Product Change Notice (PCN)

PCN Number: **PCN-0454736R-01**

Product(s) Affected: *SJ2-2577X-SMT-TR Series.*

Reason(s) for Change: *Manufacturing process improvements*

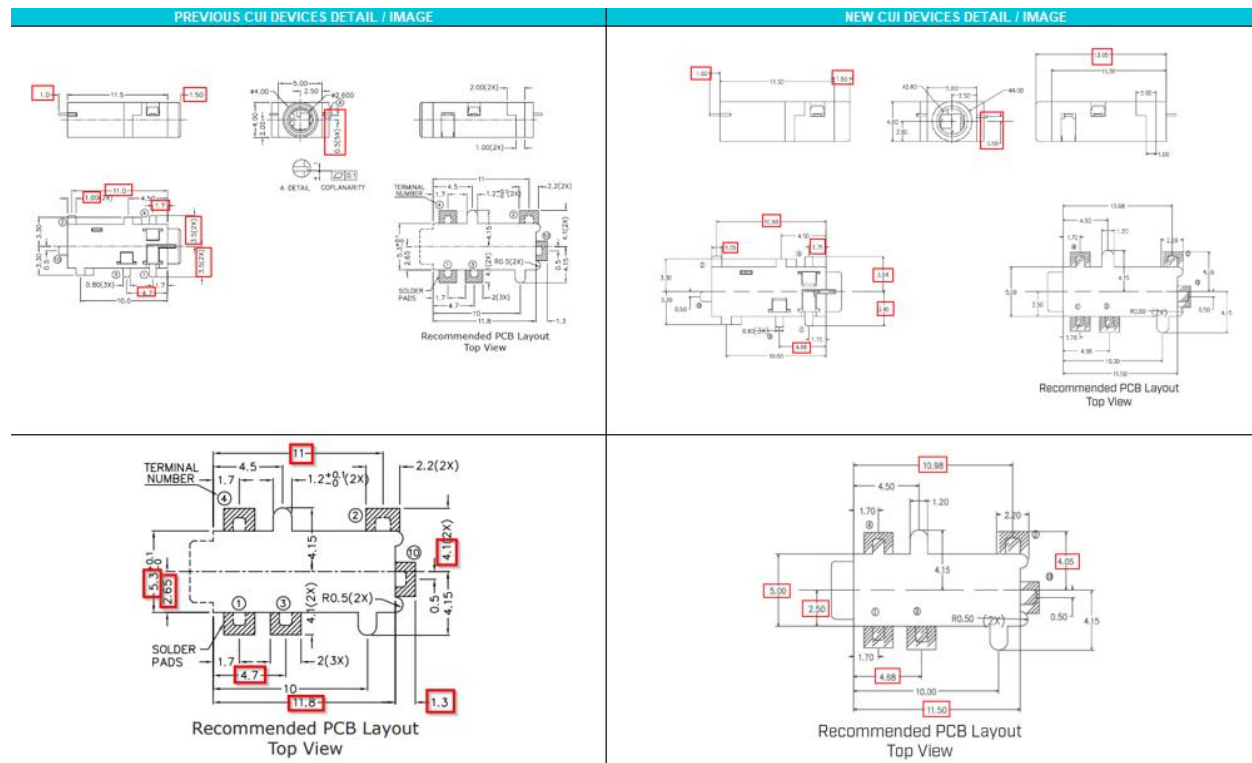
Description of Change: *Minor Housing and footprint differences. Material Change on the housing and terminals. See image Below*

PREVIOUS CUI DEVICES DETAIL / IMAGE		
	MATERIAL	PLATING
terminal 1	copper alloy	silver
terminal 2	copper alloy	silver
terminal 3	copper alloy	silver
terminal 4	copper alloy	silver
terminal 10	brass	silver
plastic	PA10T

NEW CUI DEVICES DETAIL / IMAGE		
DESCRIPTION	MATERIAL	PLATING/COLOR
terminal 1	brass	silver
terminal 2	brass	silver
terminal 3	brass	silver
terminal 4	brass	silver
terminal 10	brass	silver
housing	PA10T (UL94V-0)	black

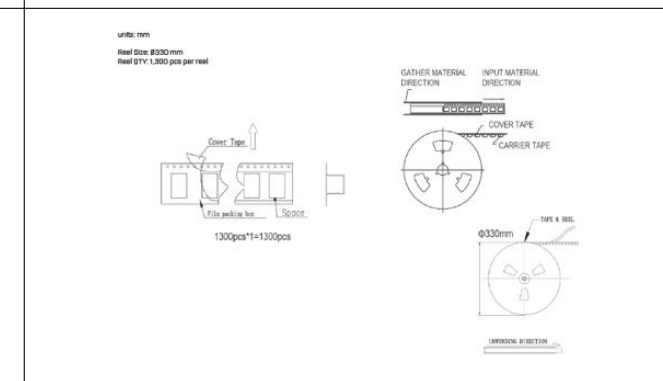
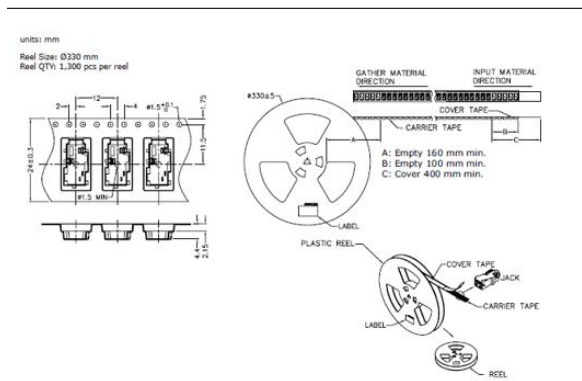
parameter	conditions/description	min	typ	max	units
reflow storage	at relative humidity $\leq 50\%$			40	$^{\circ}\text{C}$
reflow soldering ¹	see reflow profile	255	260	265	$^{\circ}\text{C}$
drying conditions ²	parts in reel: bake at $40^{\circ}\text{C} \pm 5^{\circ}\text{C}$ for 72 hours parts removed from reel: bake at $40^{\circ}\text{C} \pm 5^{\circ}\text{C}$ for 10 hours

parameter	conditions/description	min	typ	max	units
reflow storage	$10-30^{\circ}\text{C}$, $< 50\%$ humidity				$^{\circ}\text{C}$
reflow soldering ¹	see reflow profile	266	280		$^{\circ}\text{C}$
drying conditions ²	parts in reel: bake at 110°C for 4 hours parts removed from reel: bake at 110°C for 4 hours

* Time 25°C to Peak Temp. --- 8 Minutes Max.
 * Time within 5°C of Actual Peak Temp. --- 10-40 Seconds
